UNITED STATES
NUCLEAR REGULATORY COMMISSION
WASHINGTON, D.C. 20555-0001

SUBJECT: PILGRIM NUCLEAR POWER STATION - STAFF ASSESSMENT OF INFORMATION PROVIDED PURSUANT TO TITLE 10 OF THE *CODE OF FEDERAL REGULATIONS* PART 50, SECTION 50.54(f), SEISMIC HAZARD REEVALUATIONS RELATING TO RECOMMENDATION 2.1 OF THE NEAR-TERM TASK FORCE REVIEW OF INSIGHTS FROM THE FUKUSHIMA DAI-ICHI ACCIDENT (TAC NO. MF3967)

STAFF ASSESSMENT BY THE OFFICE OF NUCLEAR REACTOR REGULATION

PILGRIM NUCLEAR POWER STATION

Figure 3.3- 1 Plot of Staff's and Licensee's Base Case Shear-Wave Velocity Profiles for the Pilgrim site

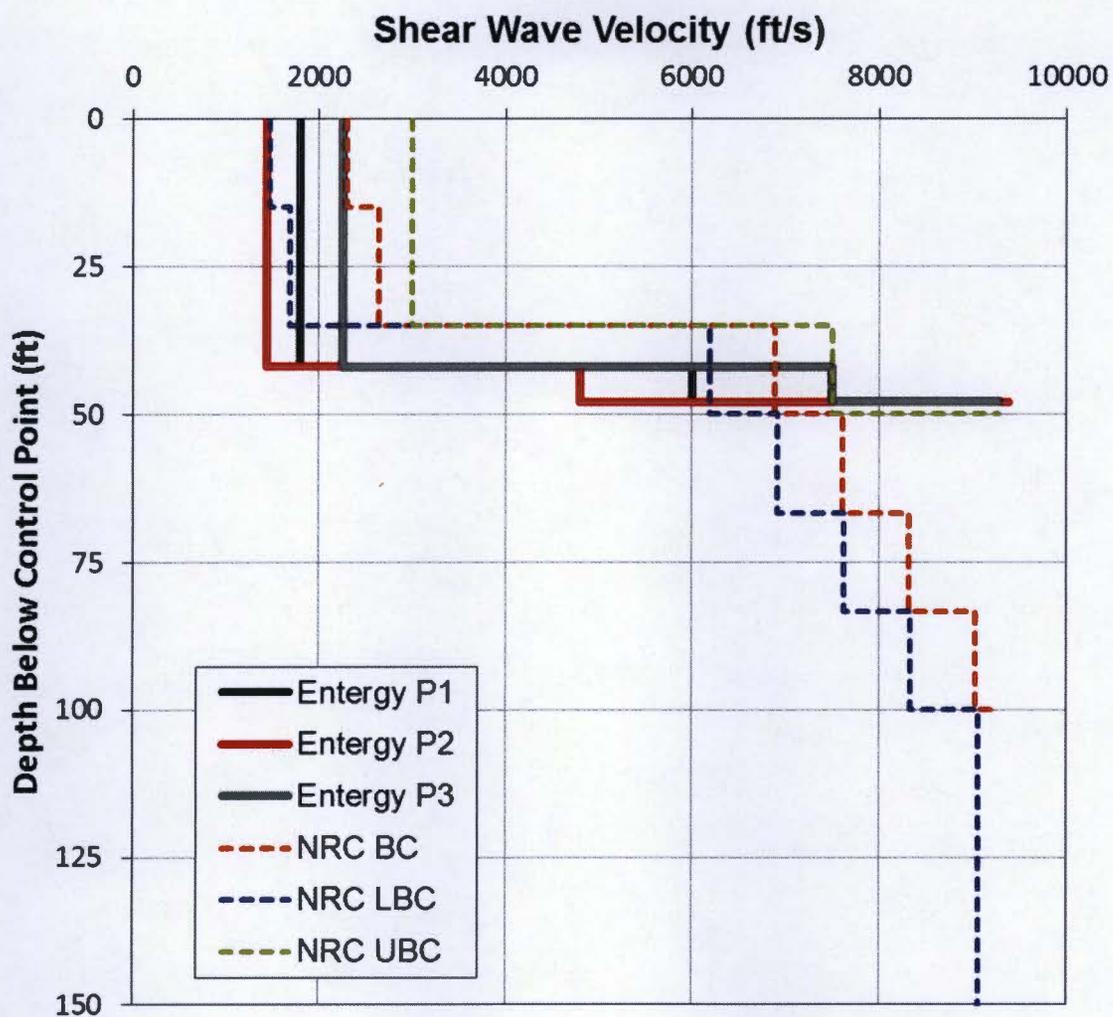
To characterize the subsurface geology, the licensee developed three site base case profiles. The middle, or best estimate profile was developed using measured shear-wave velocity from the site refraction surveys and nearby cross-hole geophysical investigations. Upper and lower base case profiles were developed using a natural log standard deviation of 0.174 and an additional scale factor of 1.28. Figure 3.3-1 shows the licensee's three shear-wave velocity base case profiles.

Based on the limited knowledge of measurement methods used to obtain the shear wave velocities reported in the General Atomic Site Parameter Study, a scale factor of 1.57 was used to obtain estimates of the lower base case velocity of the glacial soil. This scale factor corresponds to a natural log standard deviation of 0.35. The upper base case velocity of the glacial soil was limited to 3000 ft/s [910 m/s], which is less than 1.57 times the base case velocity. Measured compression wave velocities from Oldale and Tuttle (1963) were used to develop the base case velocities at the interface between the glacial soils and bedrock with an assumed gradient from this soil rock interface until reference rock velocities are reached. To capture the uncertainty in the depth to base rock, the staff used a value of ± 7 ft [± 2 m]. Figure 3.3.-1 shows the staff velocity profile compared to the base case profiles developed by the licensee.

The key differences between the staff's and licensee's approaches for site response calculations are the velocity profile and treatment of kappa uncertainty. Based on staff's review of the UFSAR, glacial soils were approximately 35 ft [10 m] thick; whereas, the licensee estimated the glacial soil to be 42 ft [12.8 m] thick. The staff relied on information in the PNPS UFSAR (Section 12.2.4.4.3) for estimating the thickness of the glacial outwash deposits. The licensee utilized 18 boring logs located near PNPS to estimate a deeper depth to bedrock. The licensee also assessed the glacial soils to have a slightly lower shear wave velocity than the staff and implemented less

Figure 3.3- 2 Plot Comparing the Staff's and the License's Median Amplification Functions and Uncertainties for two input loading levels for the Pilgrim site

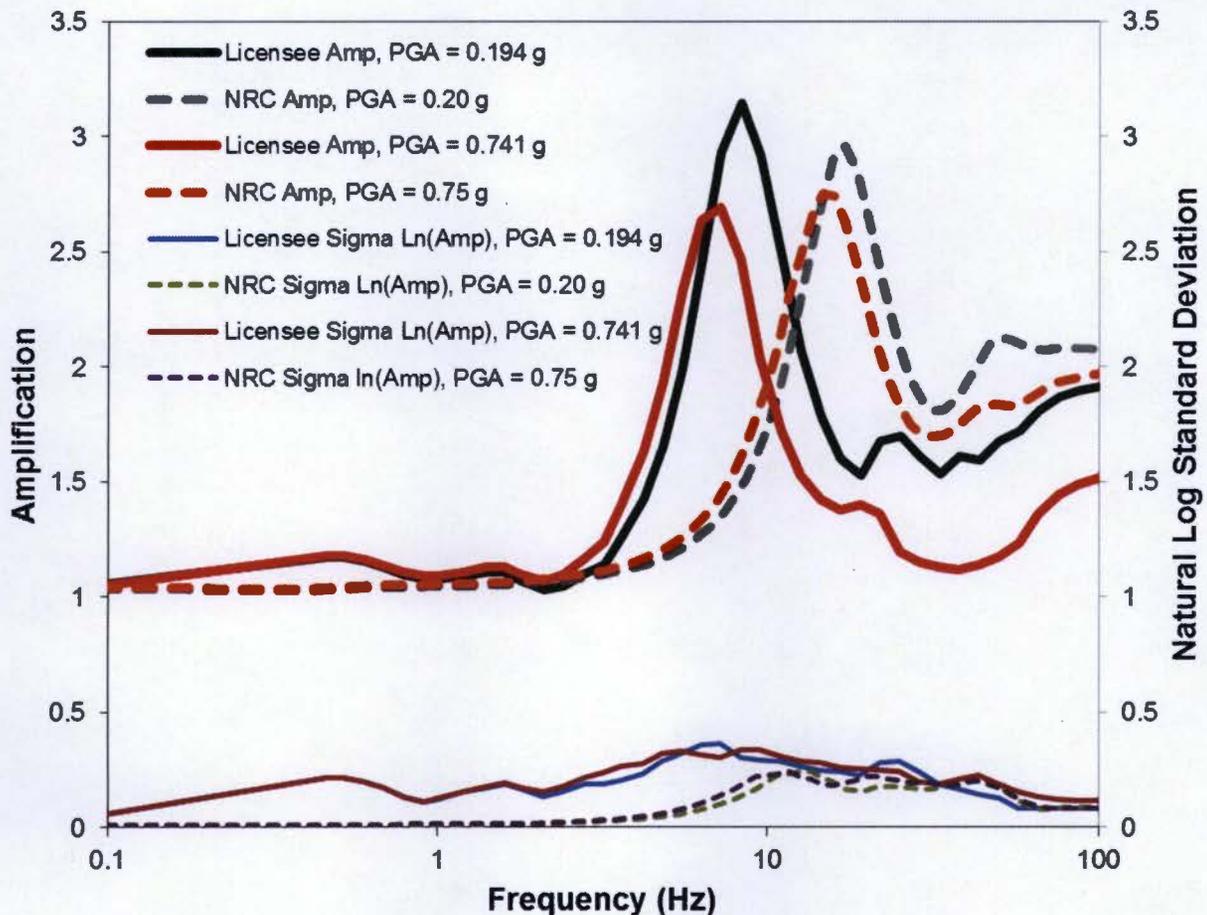
Figure 3.3-2 shows a comparison of the staff's and licensee's median site amplification functions and uncertainties for two of the eleven input loading levels. Due to differences in the near surface shear wave velocity and estimated thickness of the glacial deposits, the amplification function peaks are at different frequencies. The peaks occur near the estimated fundamental frequency of the glacial soil layer. The amplitudes of the peak amplification functions are similar.

Figure 3.3-3 Plot Comparing the Staff's and the Licensee's Mean Control Point Hazard Curves at a Variety of Frequencies for the Pilgrim site

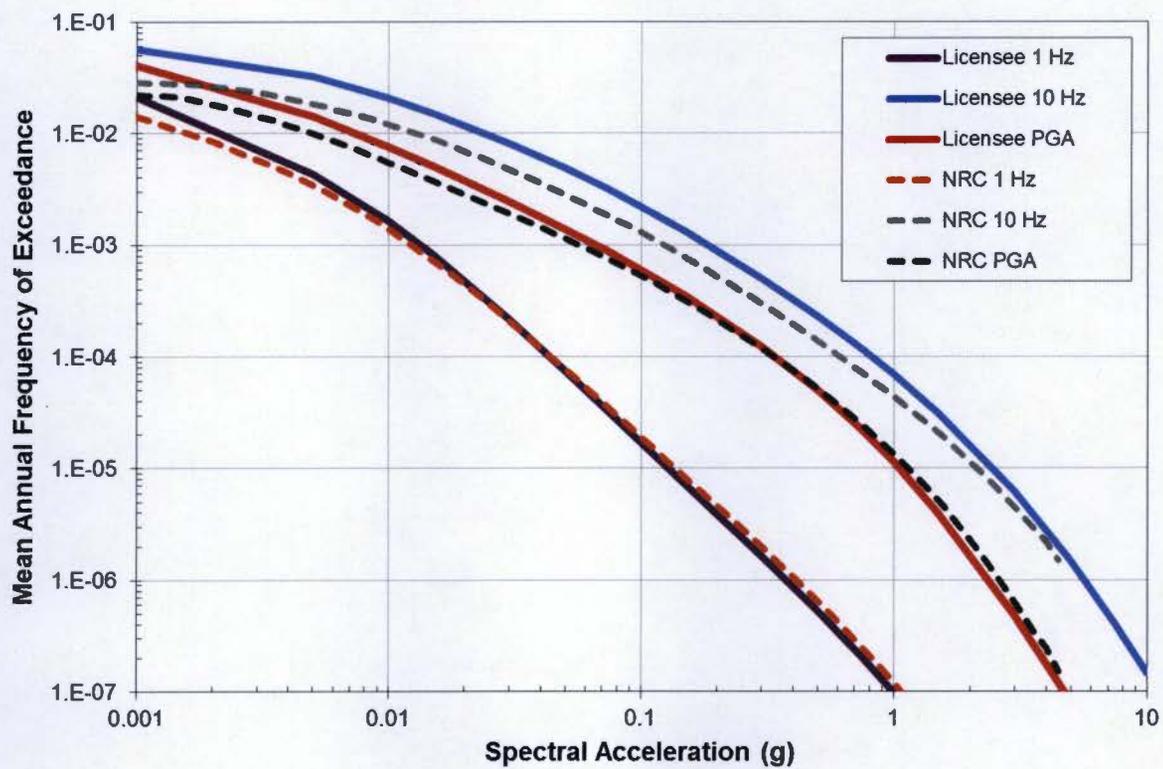
Overall, the licensee's approach to modeling the subsurface material properties and their uncertainty results in the peak of the site amplification factors occurring at a lower frequency. However, as shown in Figure 3.3-3, these differences in the site response analysis do not have a large impact on the control point seismic hazard curves or the resulting GMRS at 1 Hz or at PGA, as discussed below. The licensee's approach results in a slightly higher hazard estimate at frequencies between 3 and 10 Hz. Appendix B of the SPID provides guidance for performing site response analyses, including capturing the uncertainty for sites with less subsurface data; however, the guidance is neither entirely prescriptive nor comprehensive. As such, alternative approaches in performing site response analyses, including the modeling of uncertainty, are acceptable for this application.

Figure 3.4-1 Comparison of the Staff's GMRS with Licensee's GMRS and the SSE for the Pilgrim site

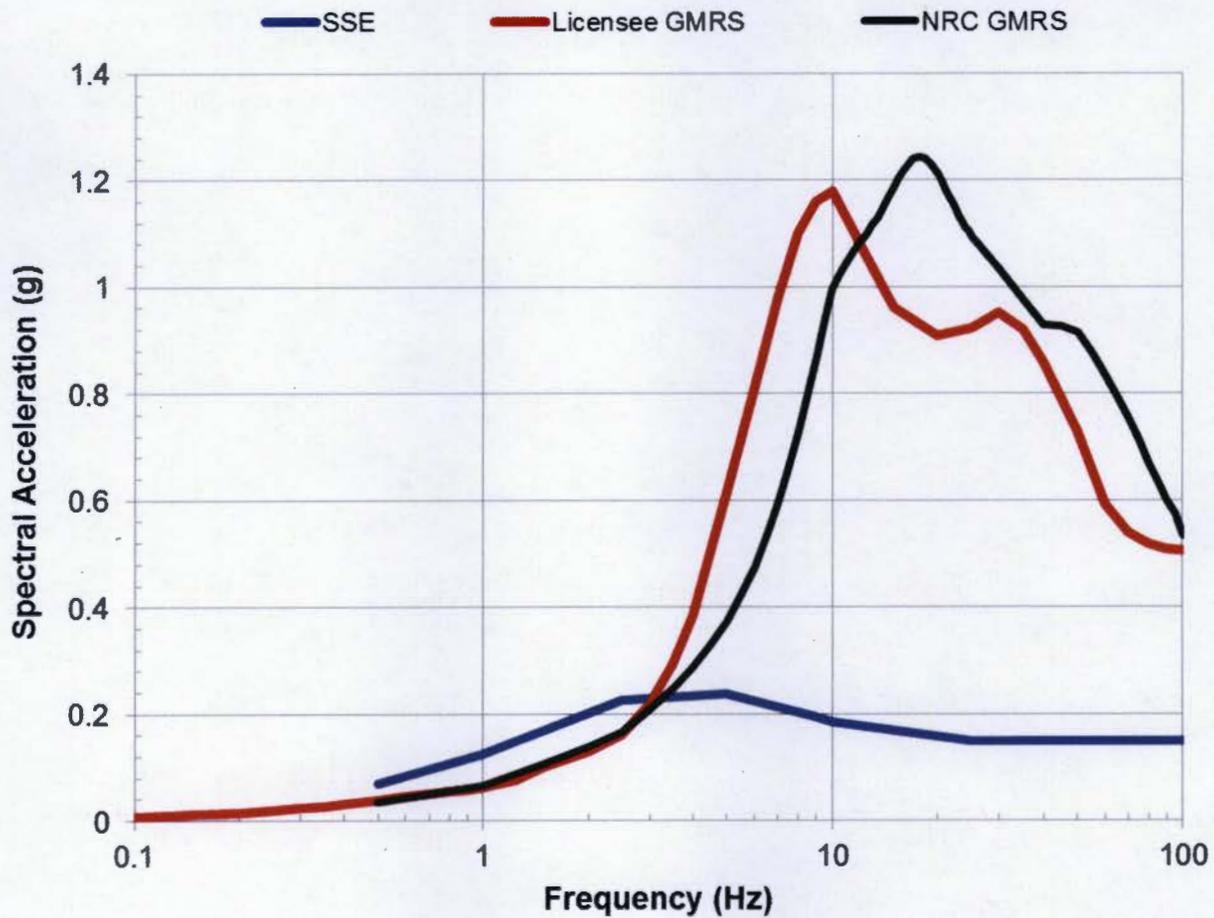
The staff independently calculated the 10^{-4} and 10^{-5} UHRS using the results of its confirmatory PSHA and site response analyses, as described in Sections 3.2 and 3.3 of this staff assessment, respectively. Figure 3.4-1 shows a comparison of the GMRS determined by the licensee to that determined by the staff.

As shown in Figure 3.4-1 below, the licensee's and staff's GMRS shape are generally similar with the peak occurring at different frequencies. The licensee's GMRS is somewhat higher than the staff's confirmatory analysis at frequencies between 3 and 10 Hz. As described above in Section 3.3, the staff concludes that these differences over this frequency range are primarily due to the differences in the site response analyses performed by the licensee and staff. The staff concludes that these differences are acceptable for this application because the licensee followed the guidance provided in the SPID with respect to both the PSHA and site response analysis for the PNPS site.

staff performed both a PSHA and site response confirmatory analysis and achieved results consistent with the licensee's horizontal GMRS. As such, the staff concludes that the GMRS determined by the licensee adequately characterizes the reevaluated hazard for the PNPS site. Therefore, this GMRS is suitable for use in subsequent evaluations and confirmations, as needed, for the response to the 50.54(f) letter.
